Re: Eldorado National - California
Defect and Non-Compliance Report

Subject: NHTSA Threshold Warning Signal Recall (Recall Number 06E-094)

Service Bulletin 34273

Instructions for Braun Corporation "Public and Private Use" Dual Parallel Arm Lift Threshold Sensitivity Evaluation and NHTSA Compliance Applicable for NL, NCL and NVL Series Lifts

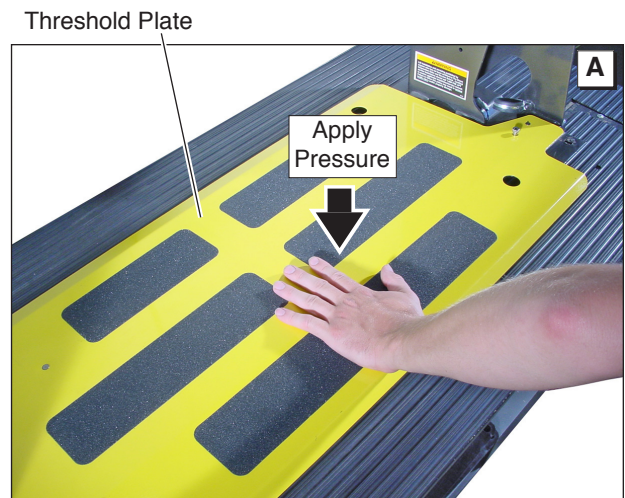
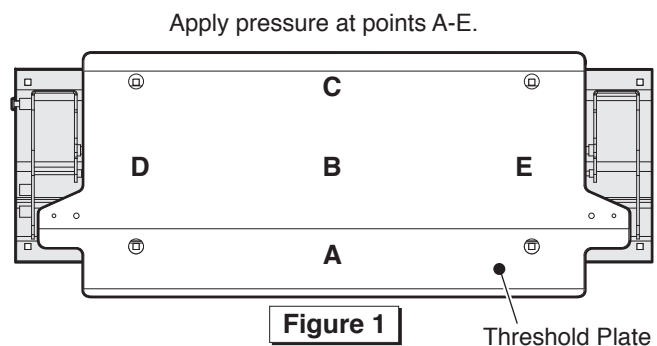
1. Turn Lift Power switch ON. Deploy the lift platform fully to the ground.
2. Apply hand pressure on the center of the threshold plate as shown in Photo A. The visual and/or audible threshold warning* should be activated when you push down.

Repeat the sensitivity test procedure at positions A-E shown in Figure 1.

3. If the threshold alarm is activated at all positions, no further procedures are required. The lift threshold sensitivity meets NHTSA FMVSS 403/404 requirements.

If the threshold alarm is not activated at all positions, perform the retrofit procedures detailed on pages 2 and 3 of this bulletin. Repeat the sensitivity test procedures following the retrofit. If the lift still does not meet the requirement, contact a Braun Corporation Product Support representatives at 1-800-THE LIFT®.

Threshold Sensitivity Retrofit Instructions

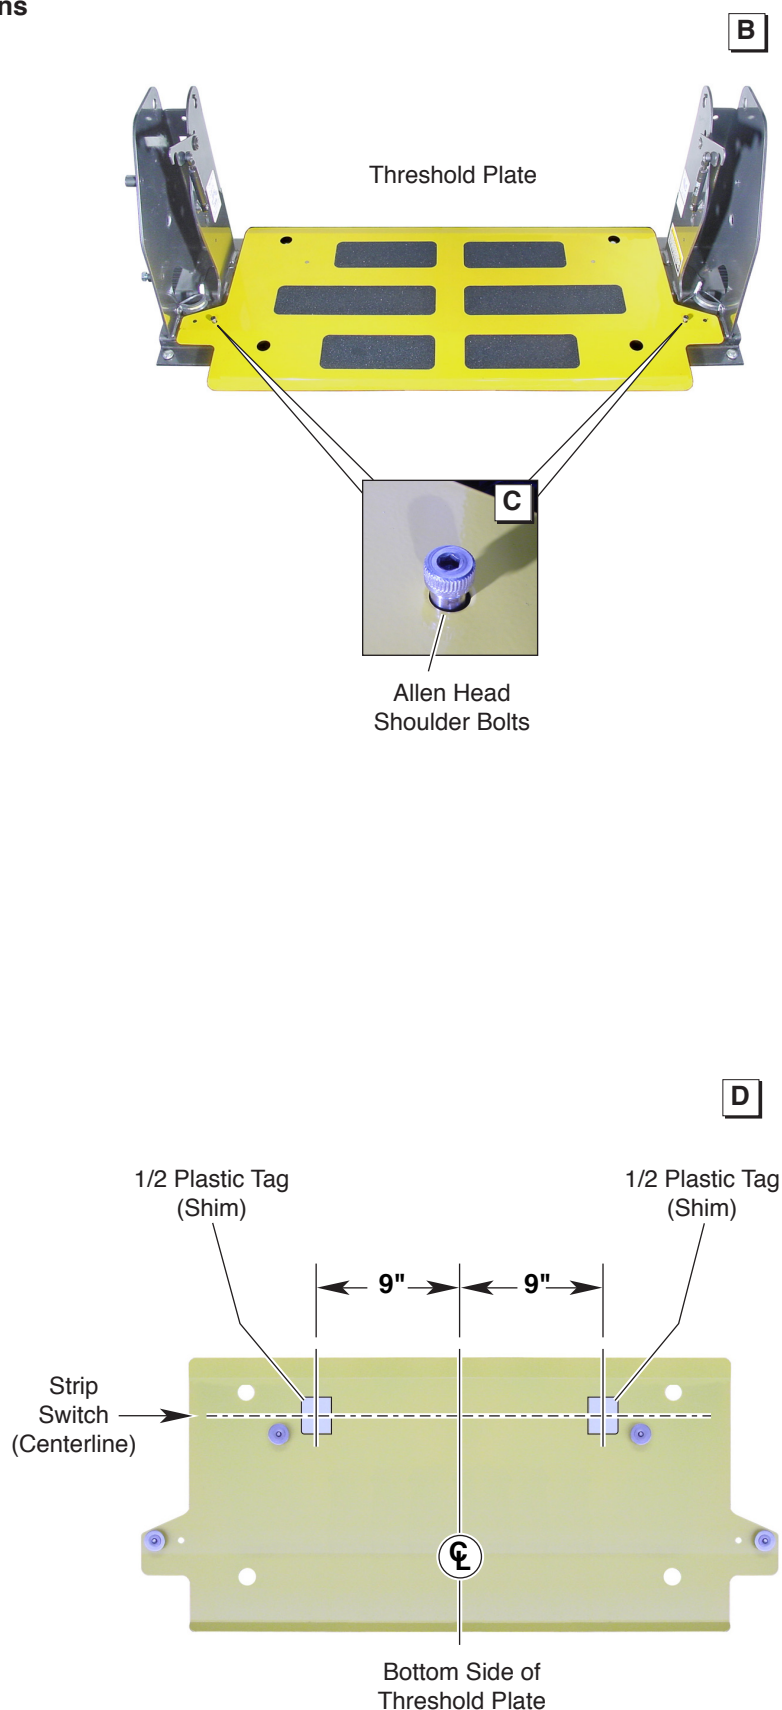
1. Turn Lift Power switch ON. Deploy the lift platform fully to the ground.
2. Remove the threshold plate. Loosen and remove two Allen head shoulder bolts securing the plate (see Photos B and C). Keep bolts. Slide the plate outward and lift to remove it (four keeper standoffs engage key-hole slots). See Photos E, F and G.
3. An adhesive-backed plastic tag is supplied to serve as an alarm activation shim (minimal thickness required to activate the highly sensitive alarm strip switches). Cut the plastic tag in two halves. The plastic tags (shims) will be affixed to the bottom side of the threshold plate (positioned as shown and detailed below).

Turn threshold plate over. See Photo D. The strip switches typically leave an impression (mark) on the yellow plate from use. Use the impression of the inboard strip switch as a centerline for shim positioning (or measure to establish position).

Position each shim 9" from the center of the threshold plate (see Photo D). Align the tags with the strip switch centerline. Clean the surface as detailed below and affix the adhesive-backed tag to the plate (**press firmly**).

Note: Clean the surface with isopropyl alcohol before affixing the tag. Use a clean cloth or paper towels. Do not use oily shop rags. Wipe surface free of residue with dry portion of cleaning cloth.

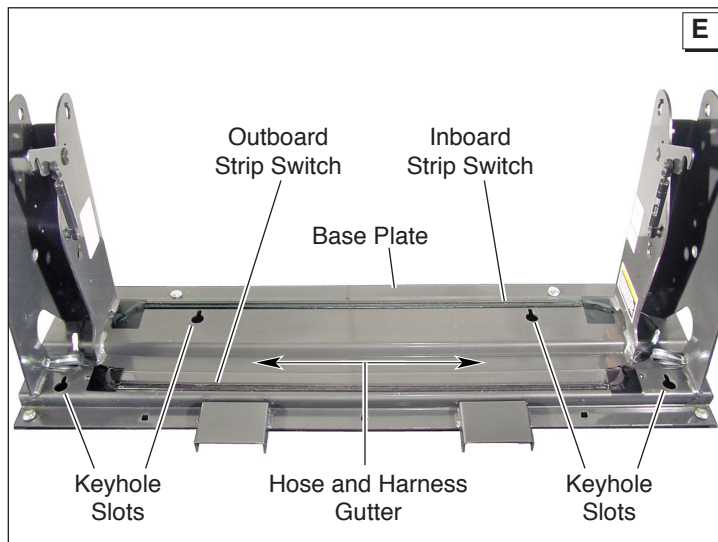
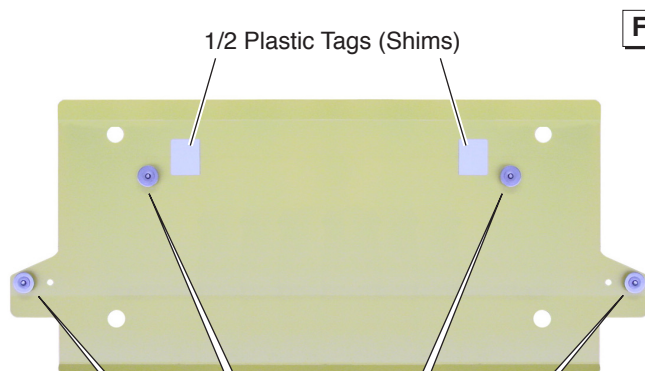
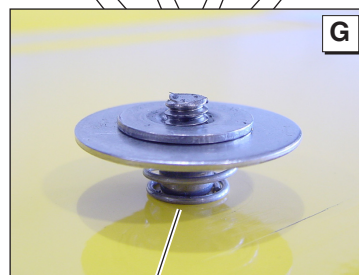
4. Reposition the threshold plate (with shim). Align the keeper standoffs (studs) on the bottom of the threshold plate with the base plate keyhole slots. See Photos E, F and G. Insert studs and **carefully** slide the plate inward (engage slots fully).

Ensure all hoses and wiring harnesses routed through the base plate gutter are positioned fully in the gutter and not located anywhere they could potentially interfere with activation of the tape switches. See Photo E.

Note: Spraying a light mist of glass cleaner (or other) to the strip switches will aid in the plate sliding easier into position. See Photos E, F and G.

Ensure all four keeper standoffs engage the base plate keyhole slots.

5. Reinstall the two Allen head shoulder bolts previously securing the plate (see Photo B and C). Tighten bolts securely.
6. Repeat the sensitivity test procedures outlined on page 1.
